Critique of Cuadrilla's plans and proposals for drilling near Balcombe, West Sussex

David Smythe

August 2013

**Cuadrilla
subsurface
geology south
of Balcombe
(2010)**

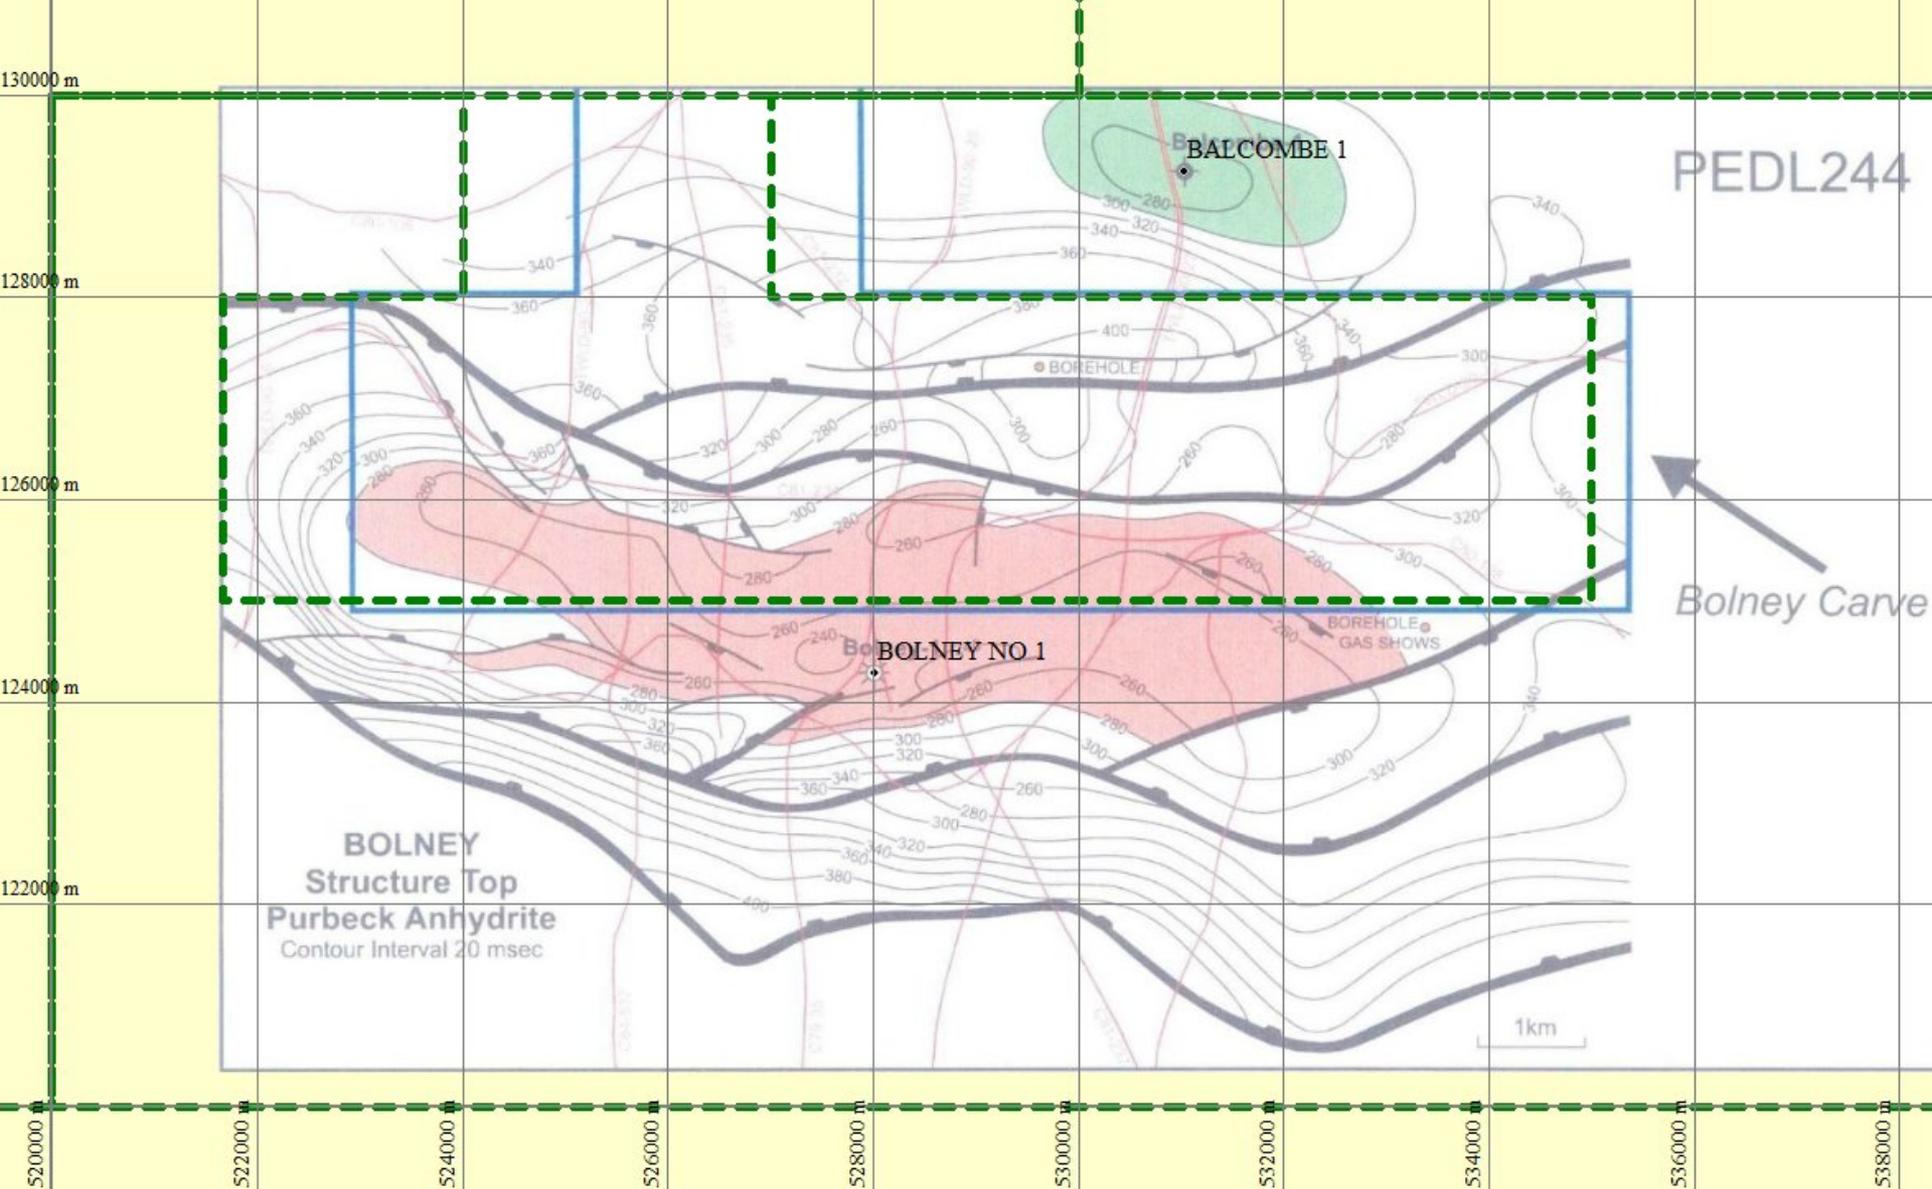
The blue polygon labelled 'Bolney carve-out' is an area *excluded* from the much larger PEDL244 licence area, but this area is wrongly positioned.

Cuadrilla mapping error

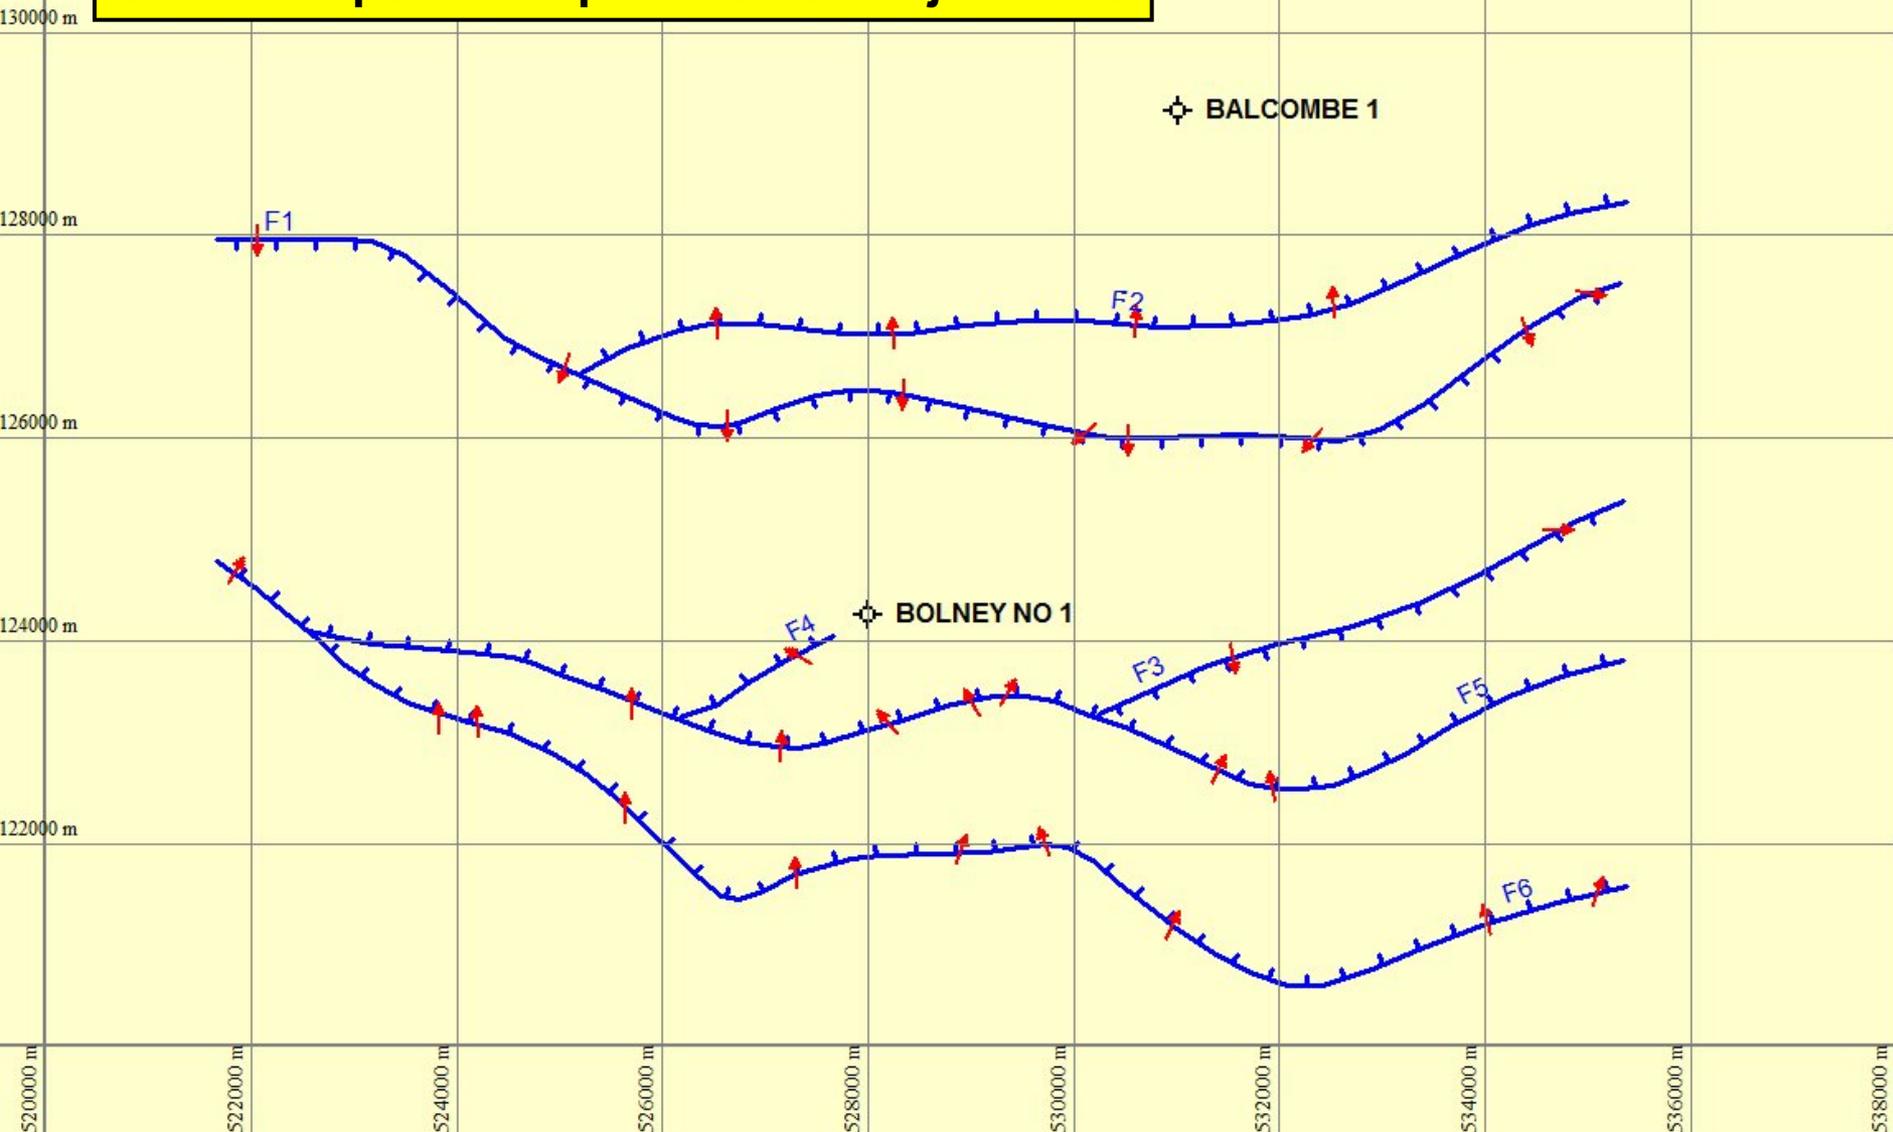
The Cuadrilla licence application map has been merged into a digital mapping program by registering it using the two wells, whose digital position is shown. A further check is that the seismic lines (red) now match the government database (not shown). But note how the DECC licence boundary (green dashes) mismatches that on the Cuadrilla map (blue) by up to 1200 m.

Cuadrilla: poor interpretation of major faults

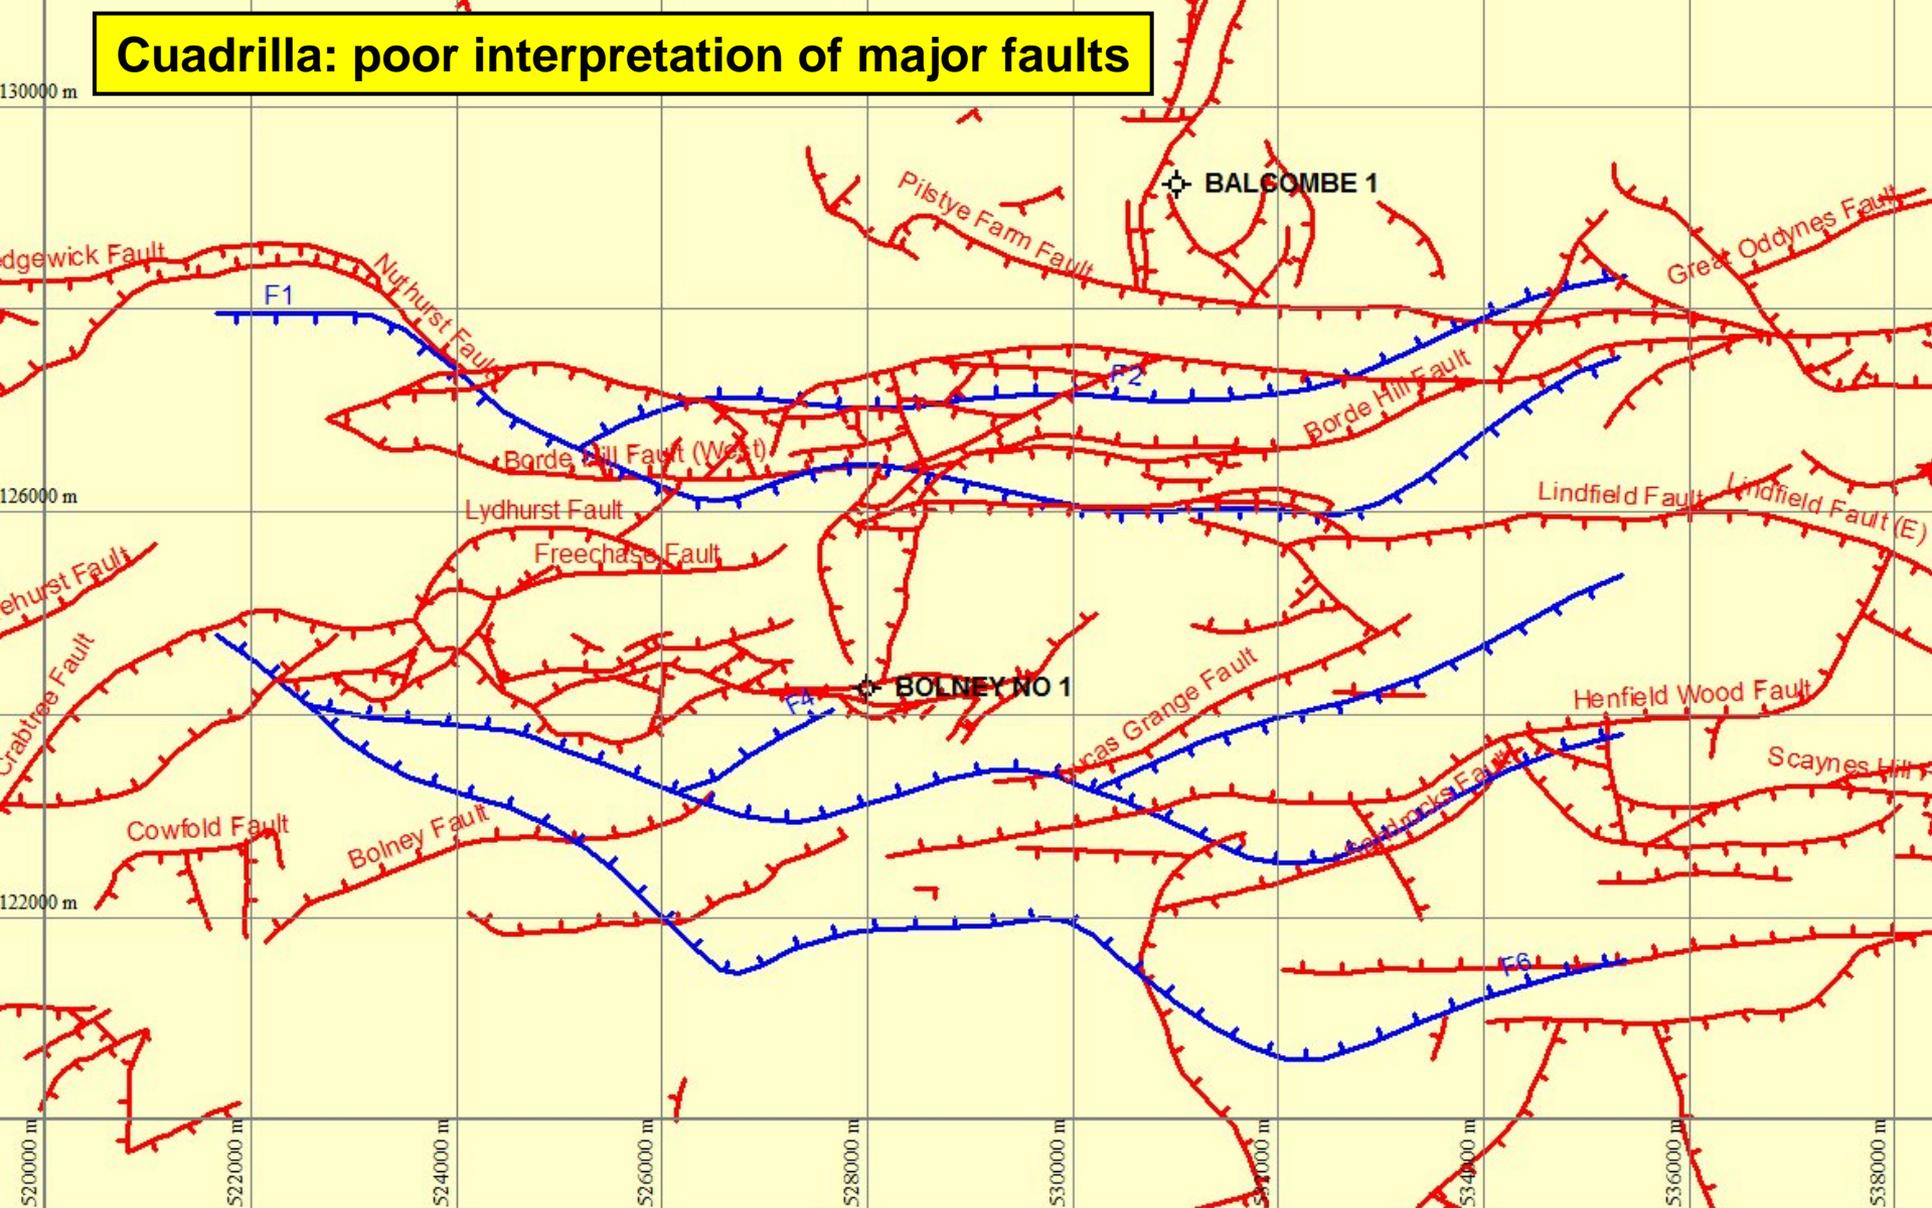
The major faults mapped by Cuadrilla are in blue, with control points from 2D seismic lines shown by red arrows. The direction of arrow is along the seismic line, pointing to the downthrown side of the fault (shown by the comb marks on the faults).

Cuadrilla: poor interpretation of major faults

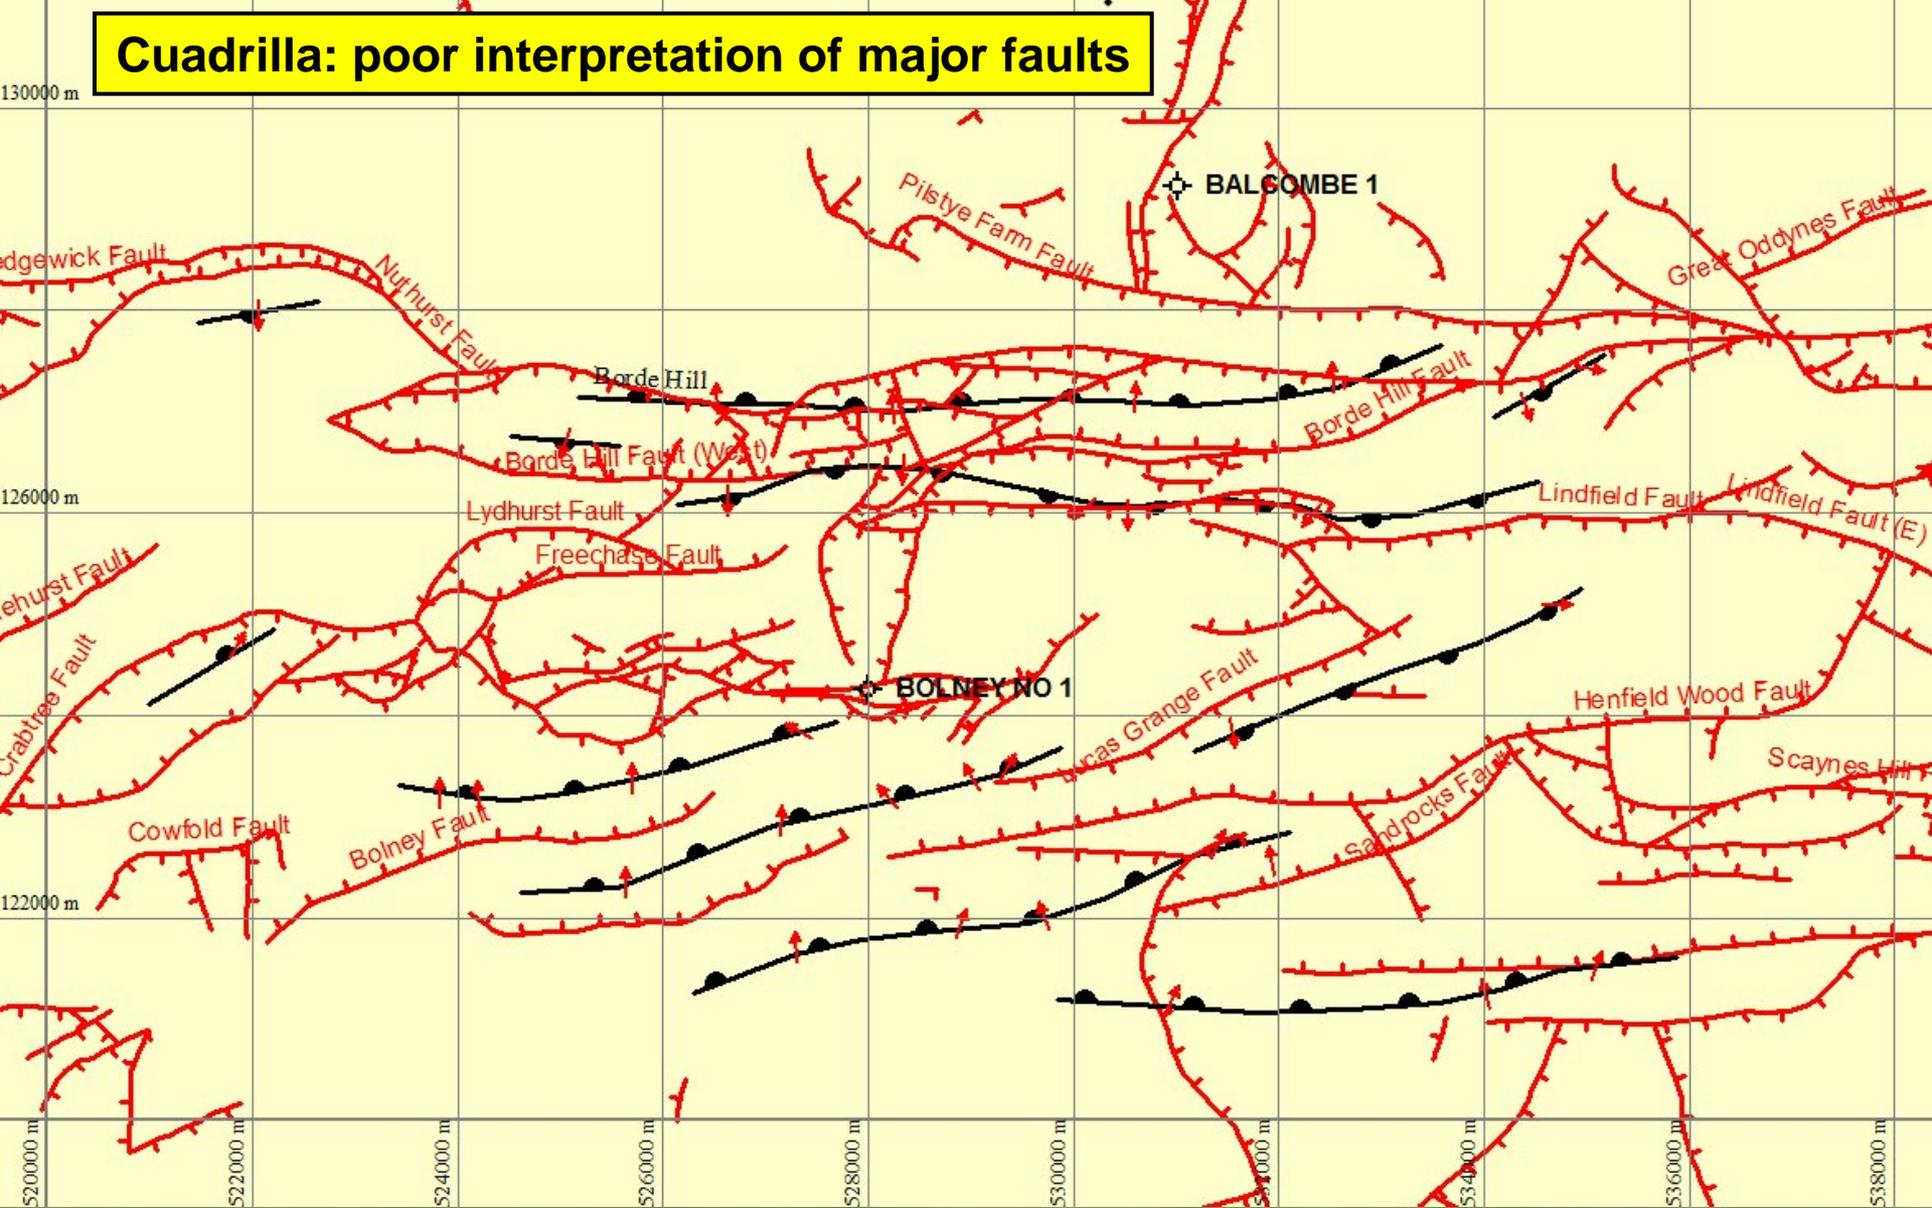
In the southern part of the interpretation the Cuadrilla faults at around 500 m depth have poor correlation of trend compared to the surface faults (red) as mapped by the BGS.

Cuadrilla: poor interpretation of major faults

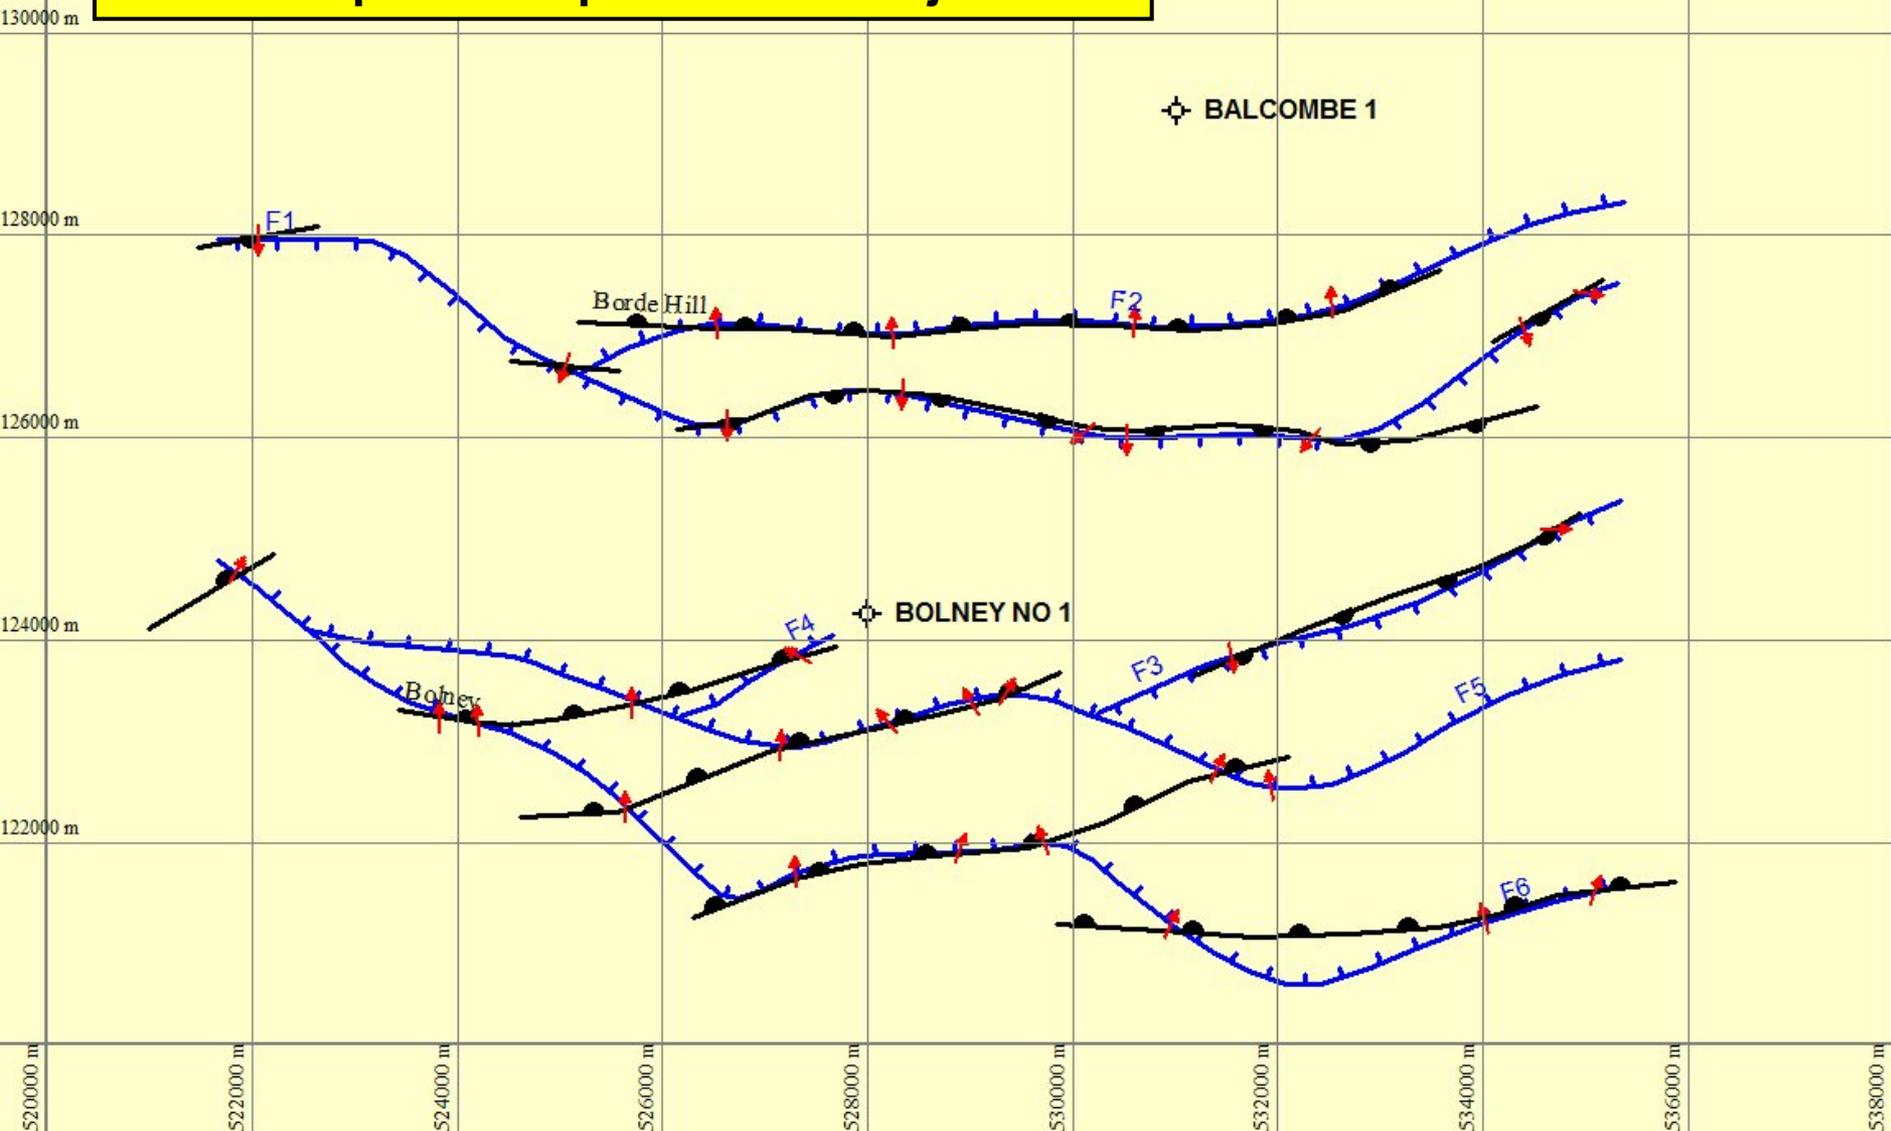
The black lines with half-moons are my re-interpretation of the major faults at depth, honouring the control points (red arrows) and also the general trend of the surface faulting.
